Architect's Supplemental Instructions

Architect's ASI No: 056

Project:
Webster University
Interdisciplinary Science
Building

Modification to Shade scope of work to include additional room darkening capability at laboratories - as requested by Webster University.

A0702.A

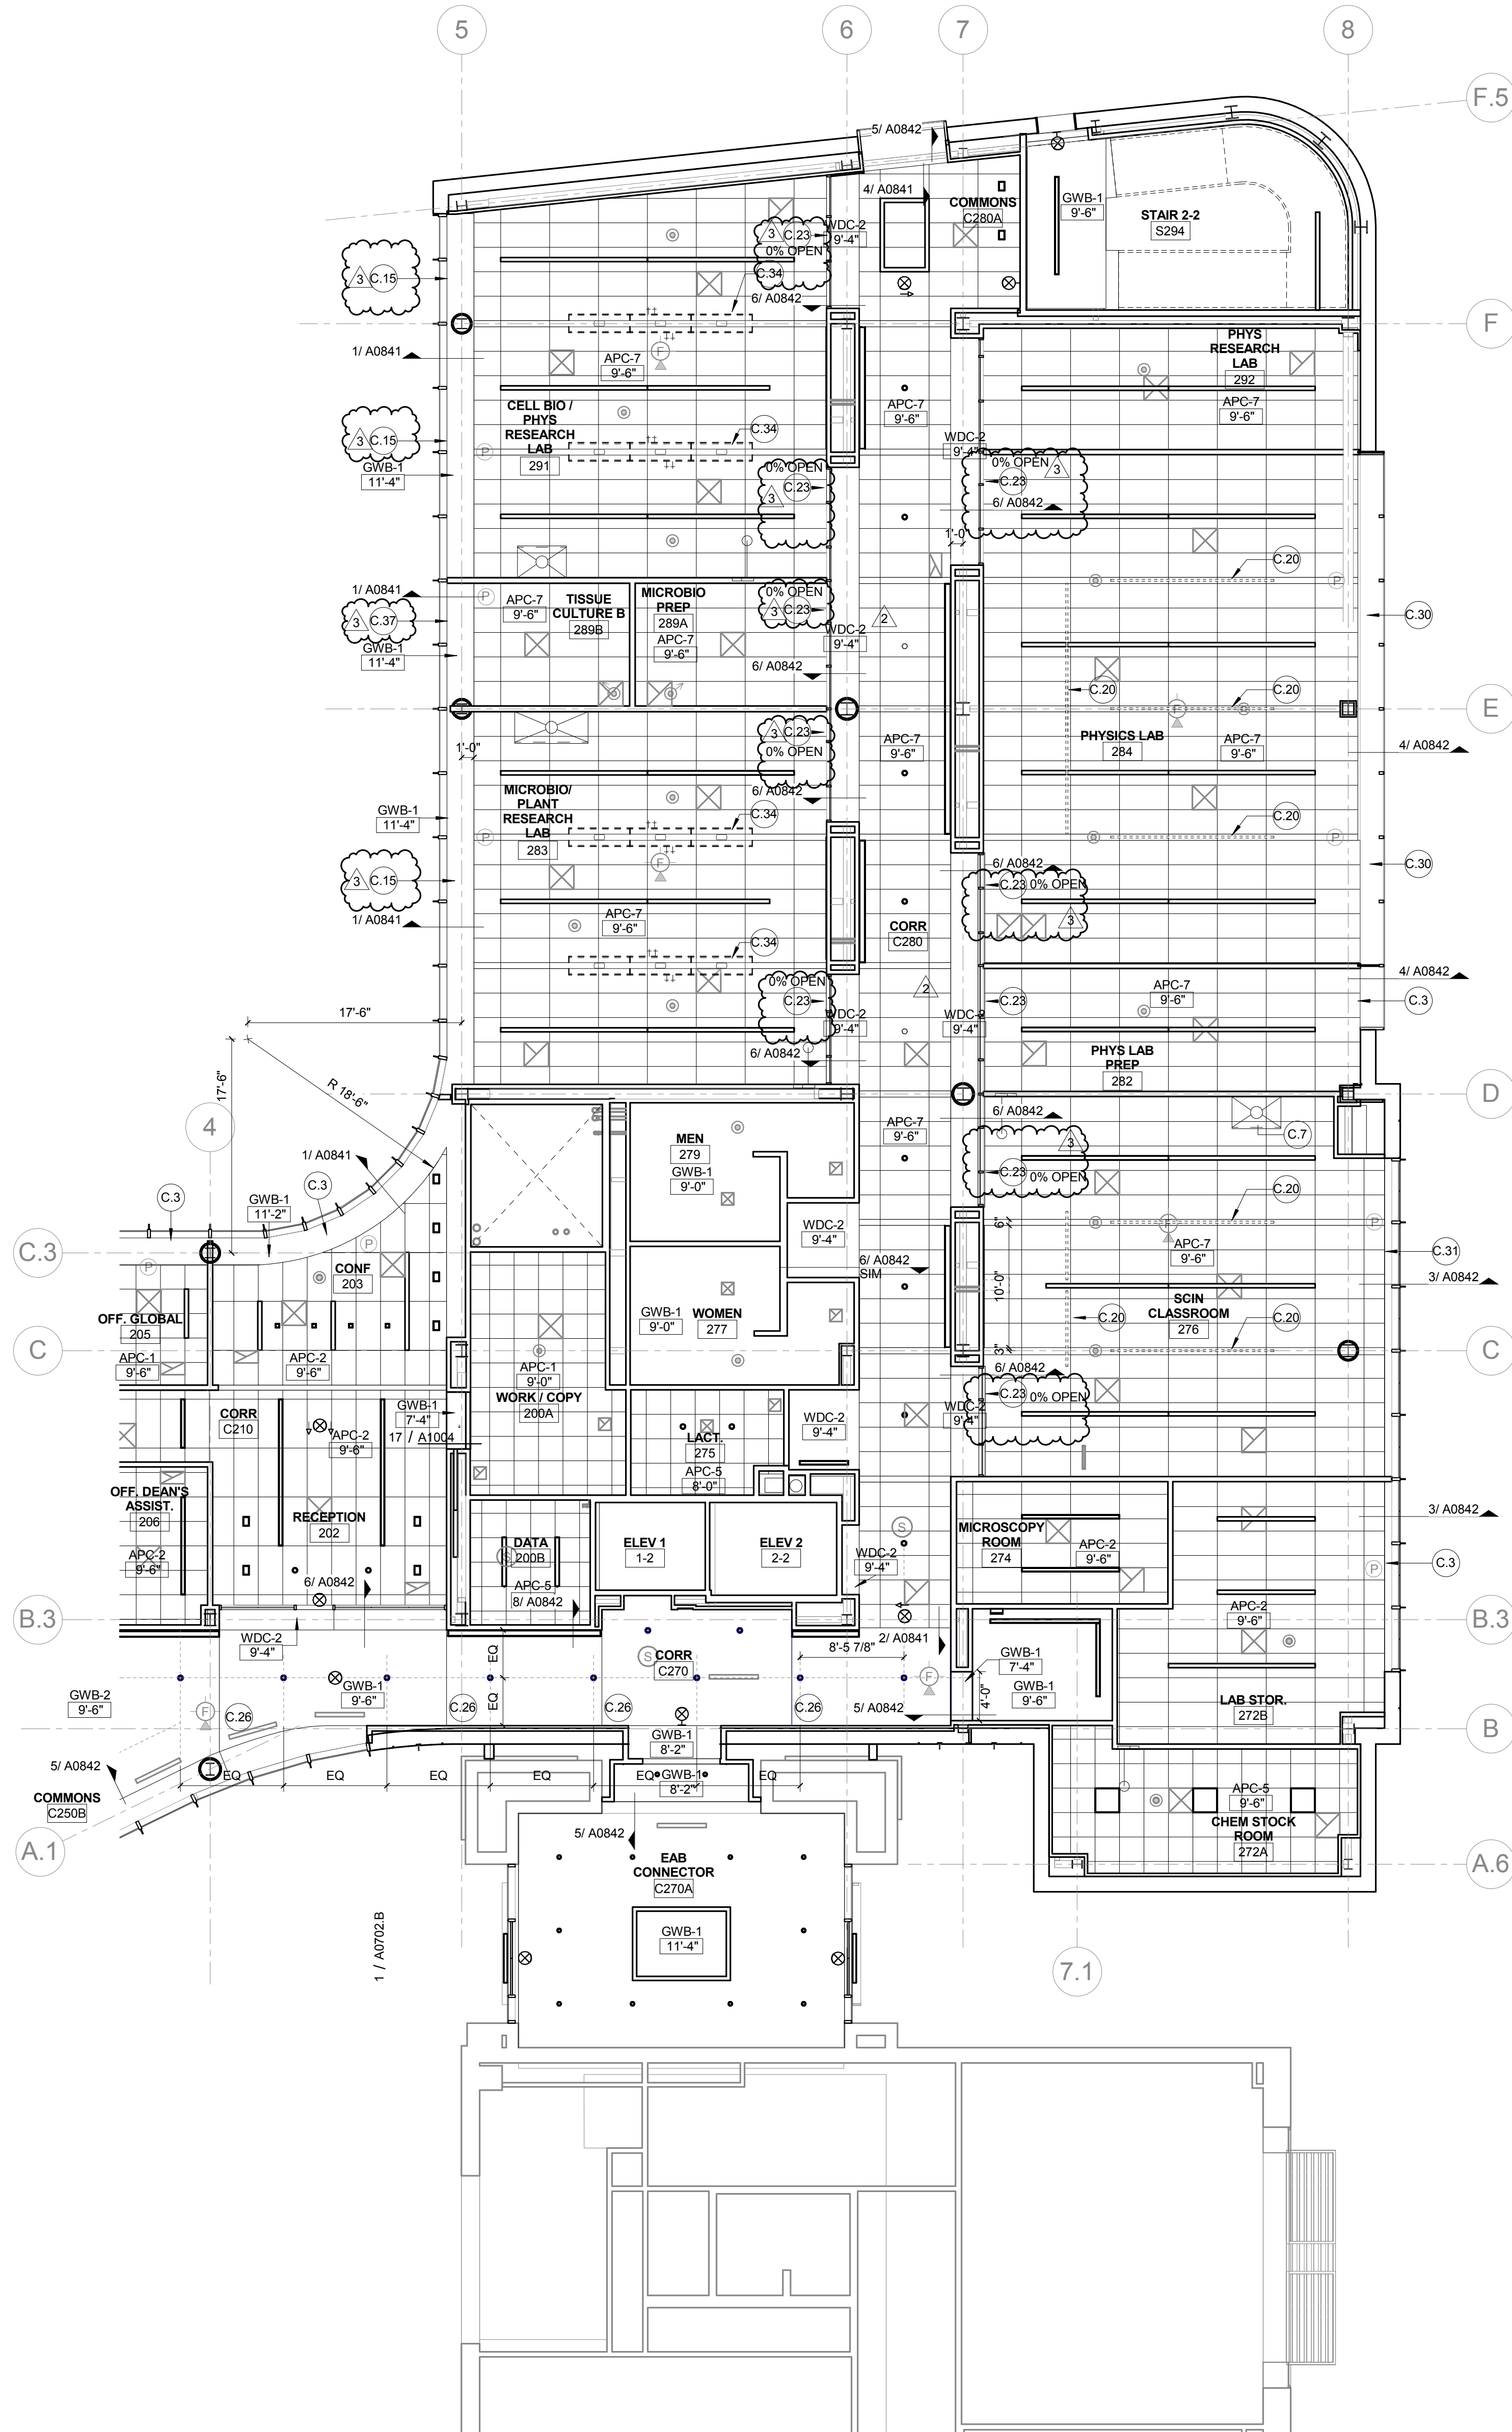
- C.35 EMERGENCY SAFETY SHOWER - PIPING TO HEAD ABOVE CEILING
- C.36 122413 TYPE 3 SHADES: MANUAL SHADES - STEPPED WITH SLOPE IN CONT. SLOPED OPENING
- C.37 122413 TYPE 9 SHADES: DOUBLE MANUAL SHADES IN RECESSED POCKET

A0704.A

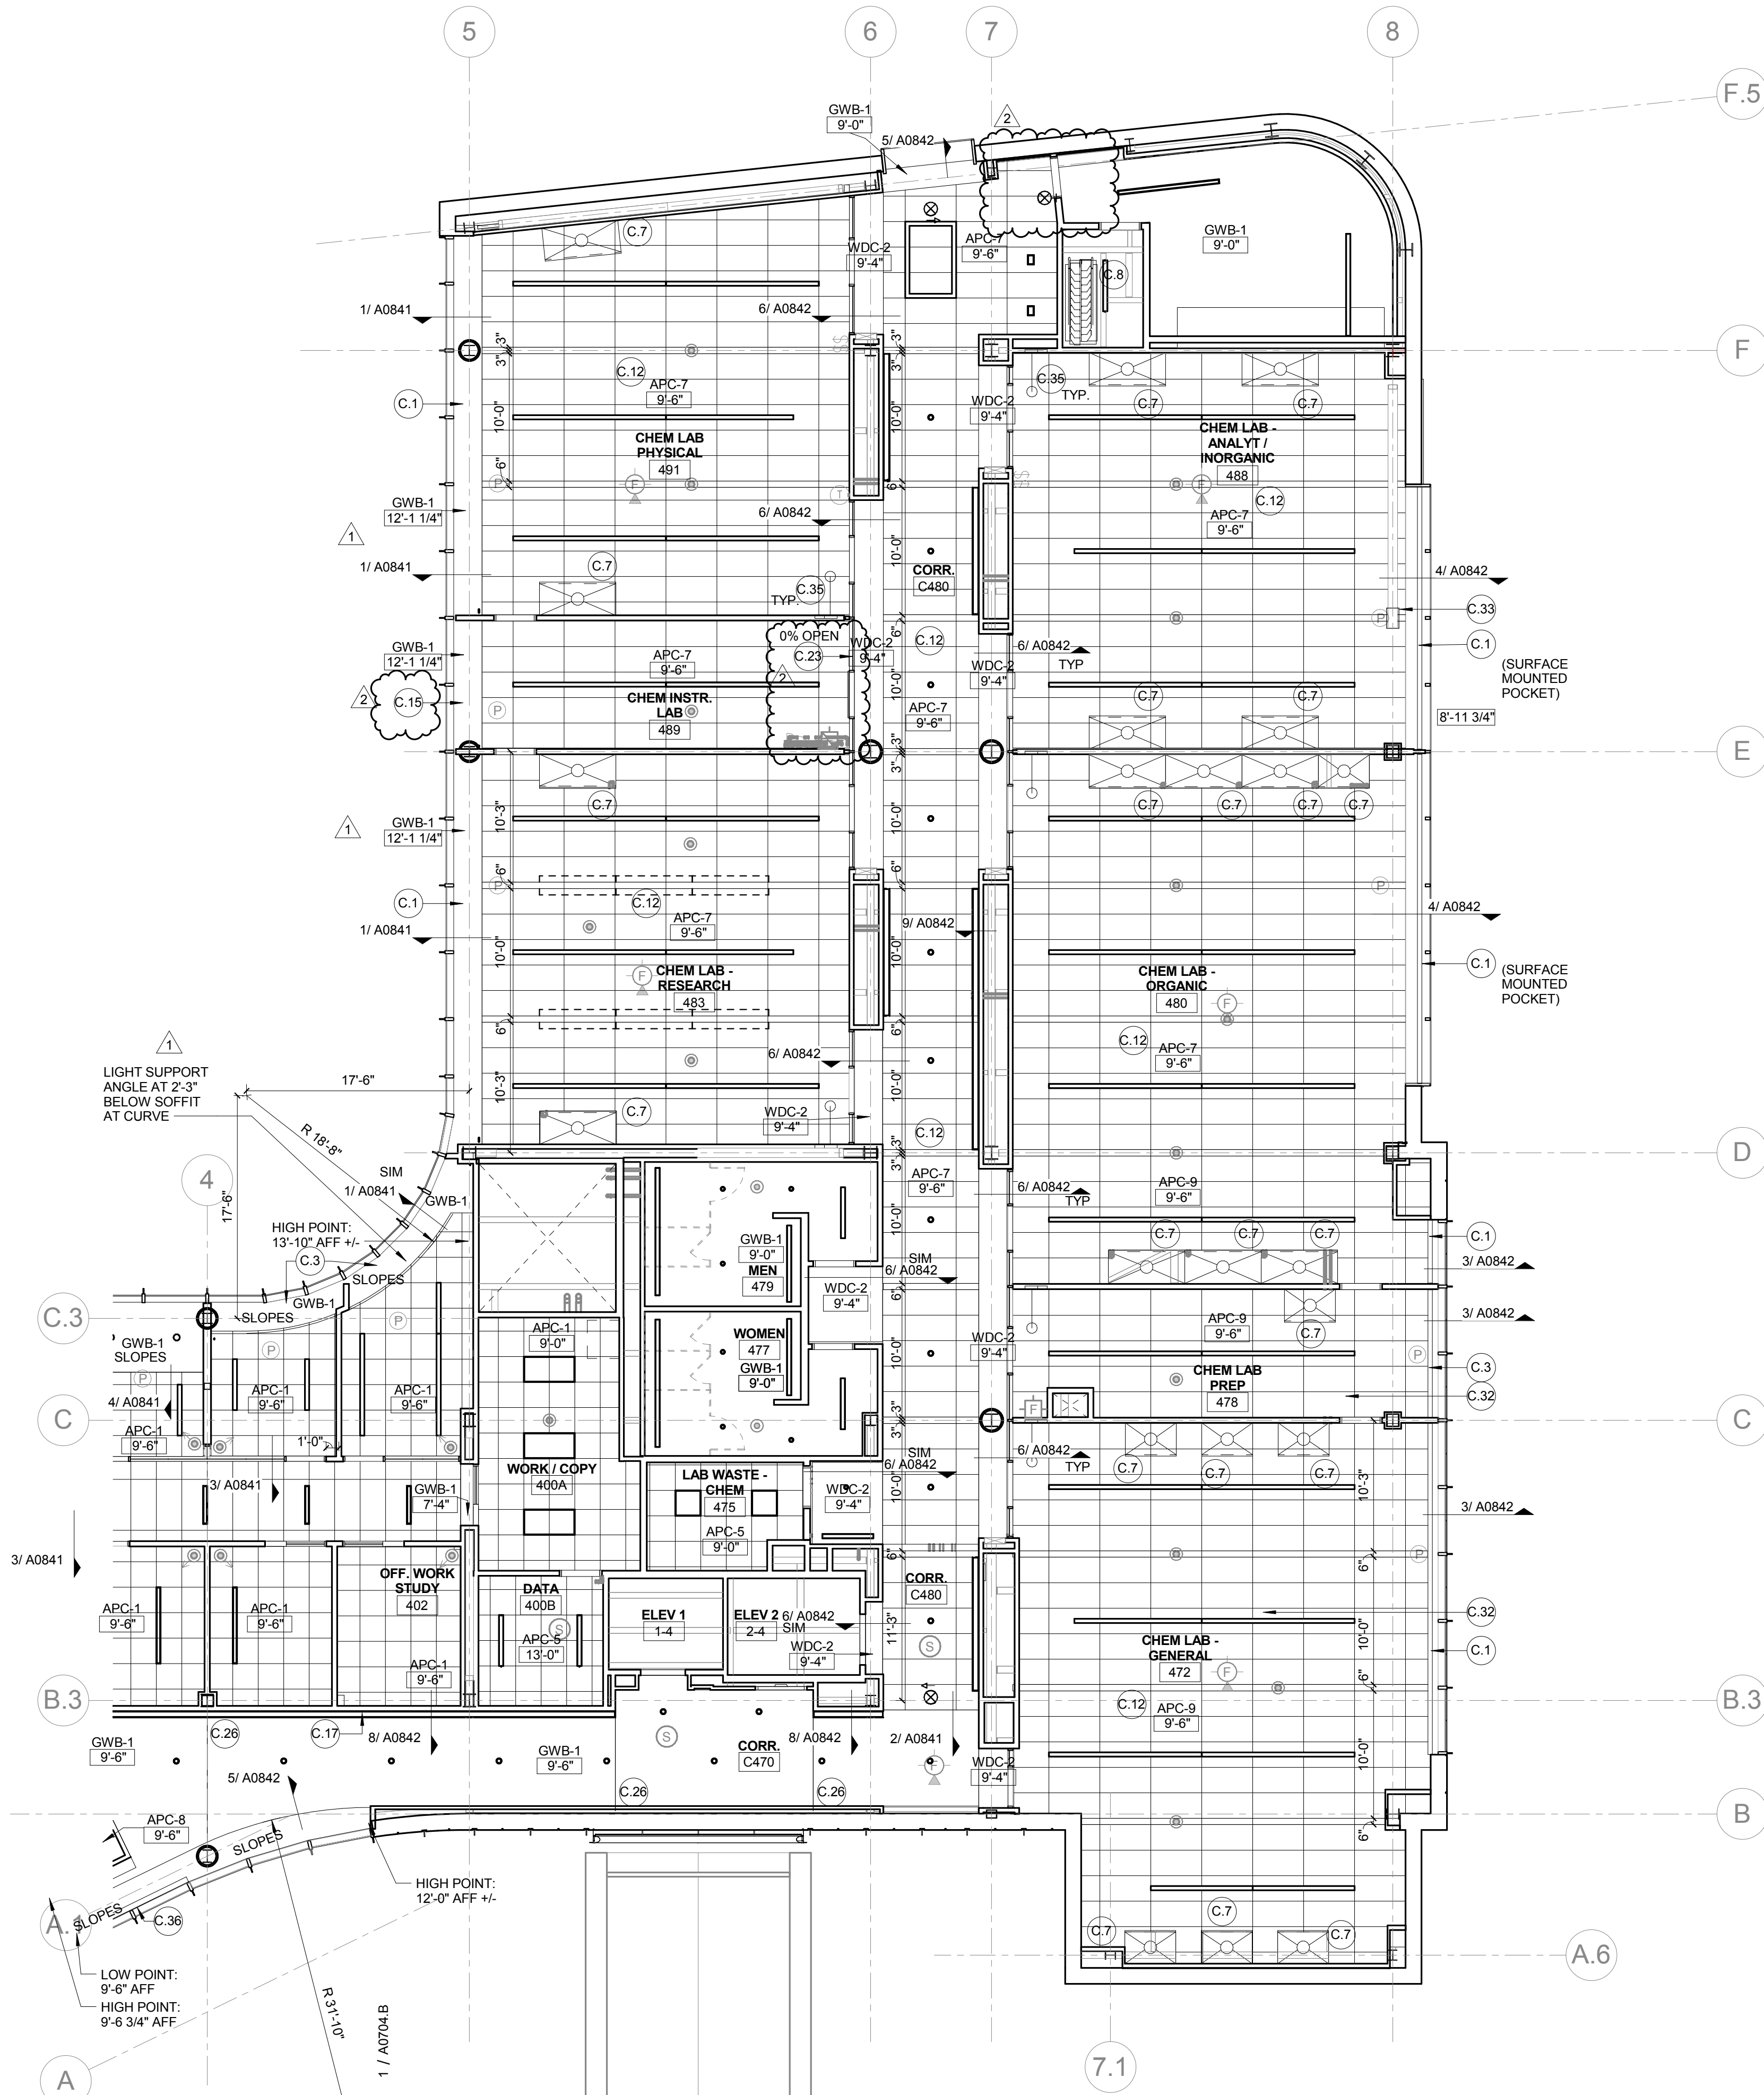
- C.36 122413 TYPE 3 SHADES: MANUAL SHADES - STEPPED WITH SLOPE IN CONT. SLOPED DRAINING
- C.37 122413 TYPE 9 SHADES: DOUBLE MANUAL SHADES IN RECESSED POCKET

Interior Shading Strategies

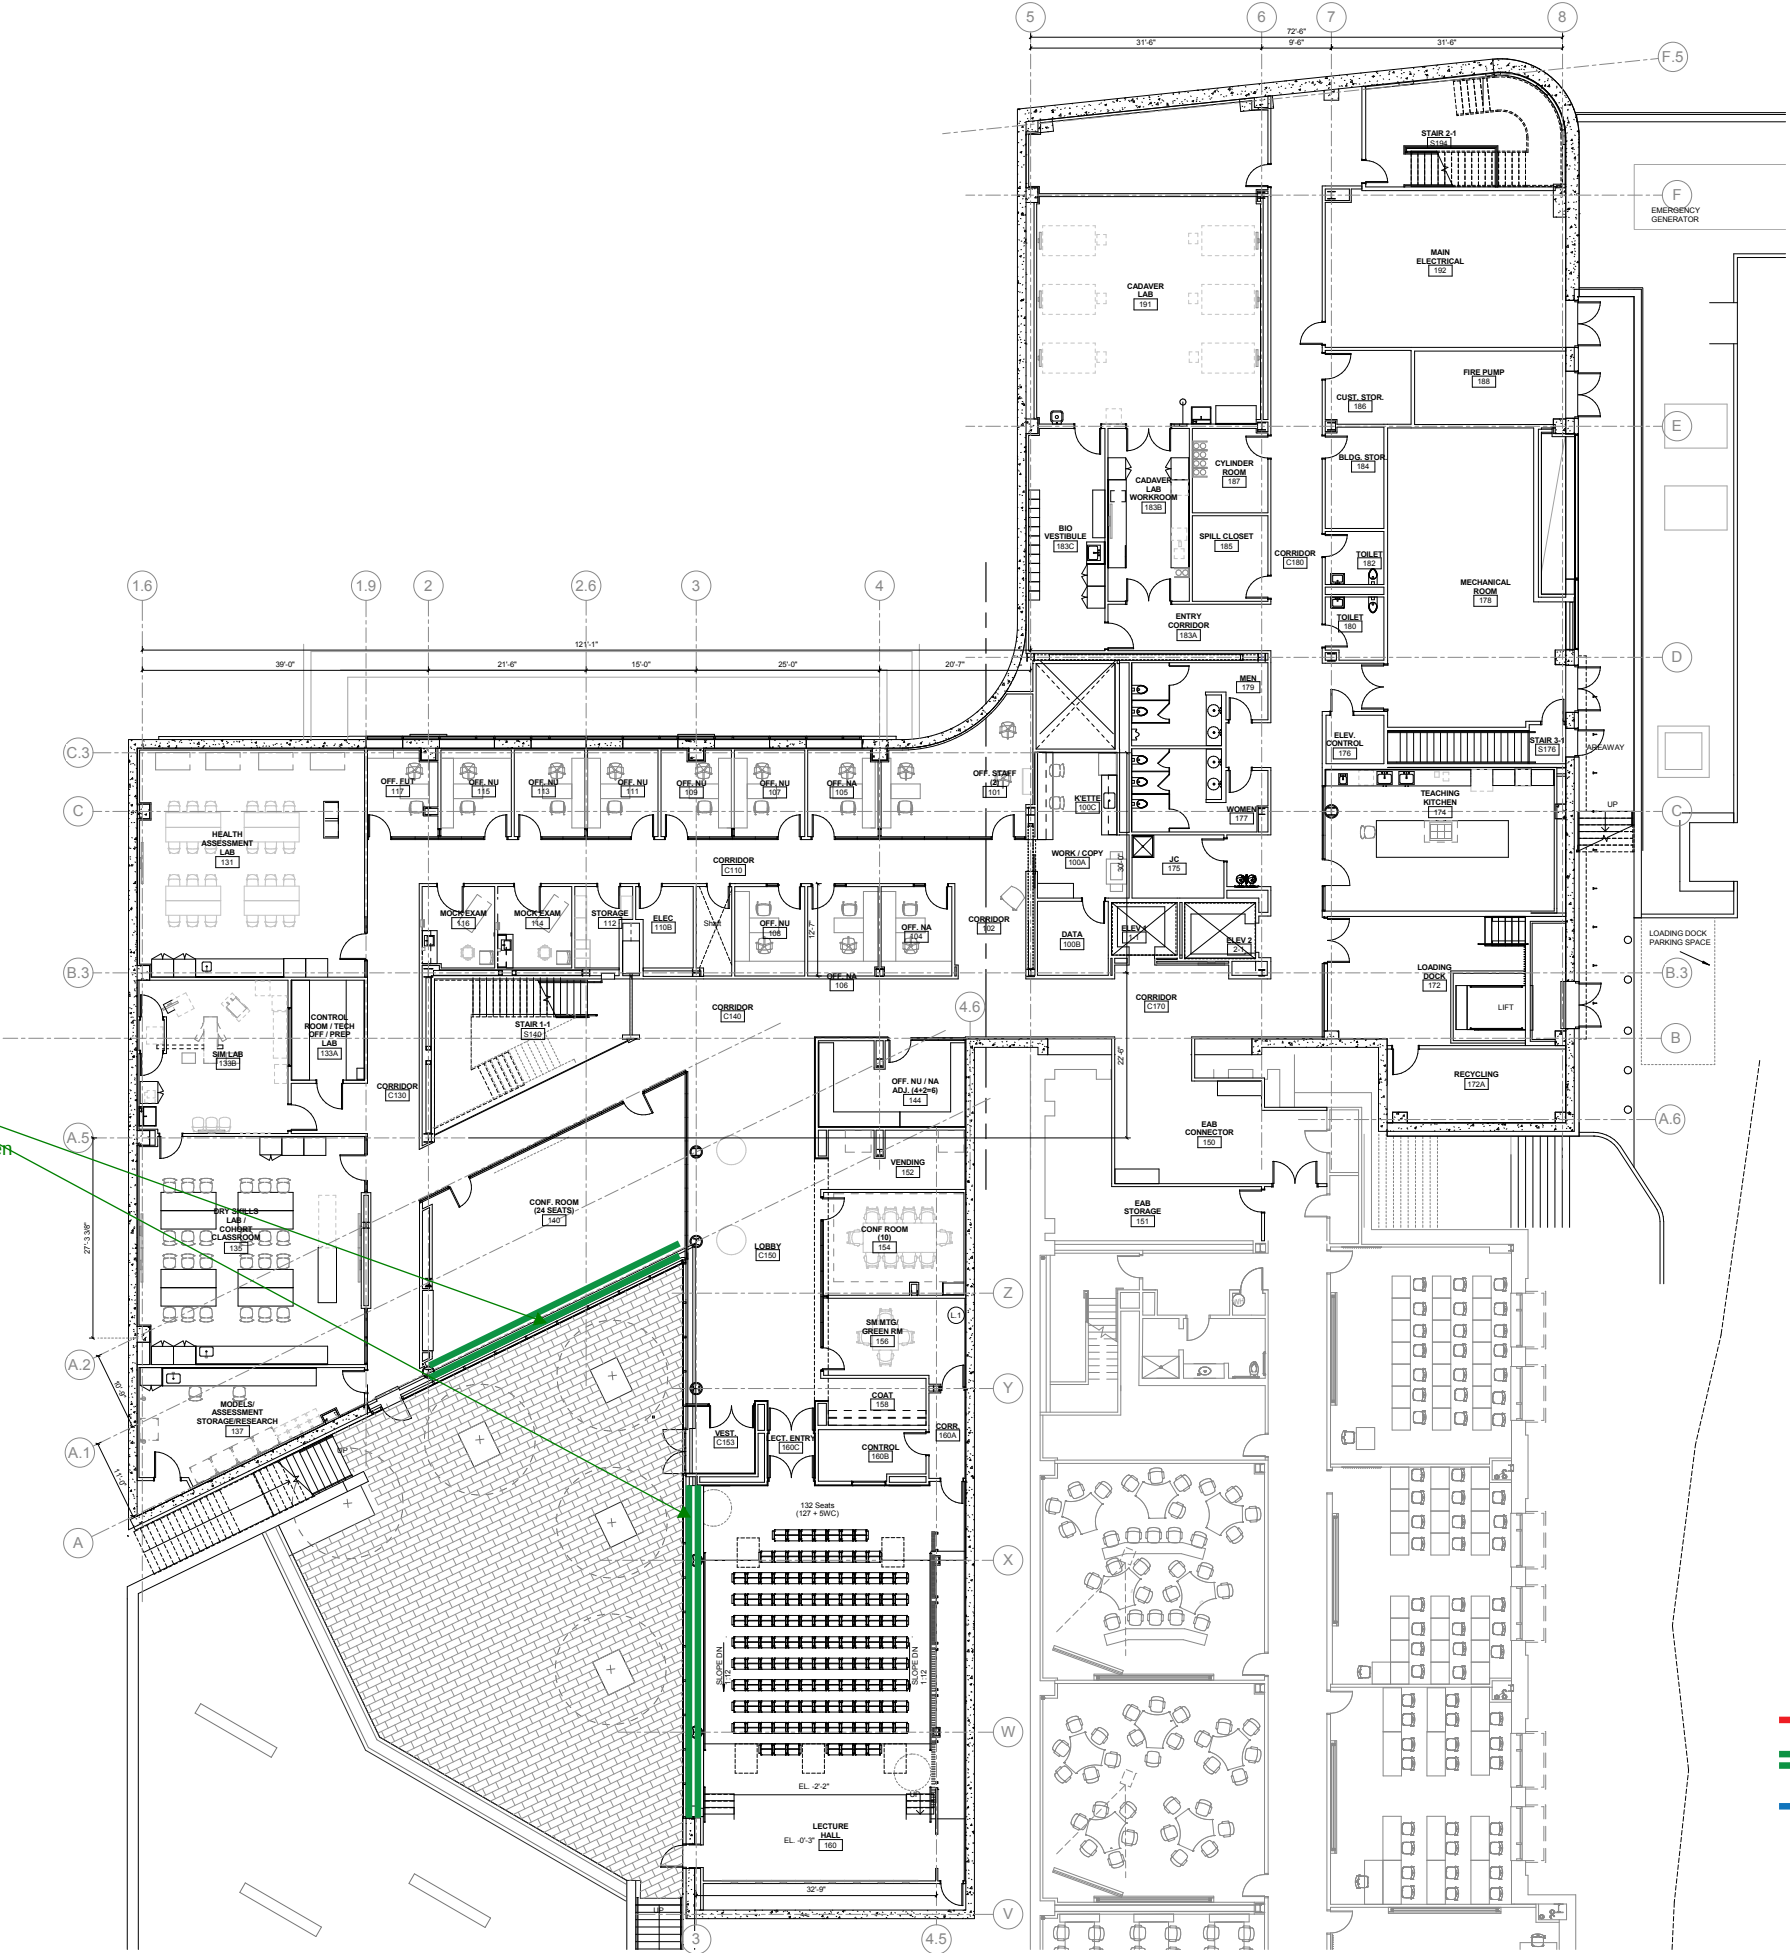
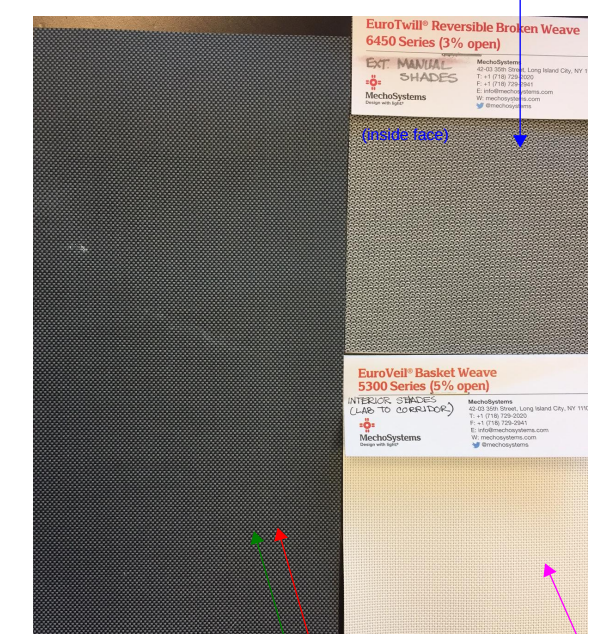
In addition, Shadecloth selection diagram is included.

All locations with Green line:
Motorized Double Shades:
Exterior Shade: Lutron E Screen 3% open
S3001-E-3 - Charcoal/Grey
WSF-S3001-E-3

All locations with Red line:
Motorized Shades:
Lutron E Screen 3% open
S3001-E-3 - Charcoal/Grey
WSF-S3001-E-3

Locations with Blue line:
EuroTwill Reversible Broken Weave
6450 Series (3% open)
6462 - Light Charcoal
(dark to exterior light to interior)

Interior shade locations with Pink line:
Mecho Shade EuroVeil Basket Weave
5300 Series (5% open)
5301 - White
(matches frames)
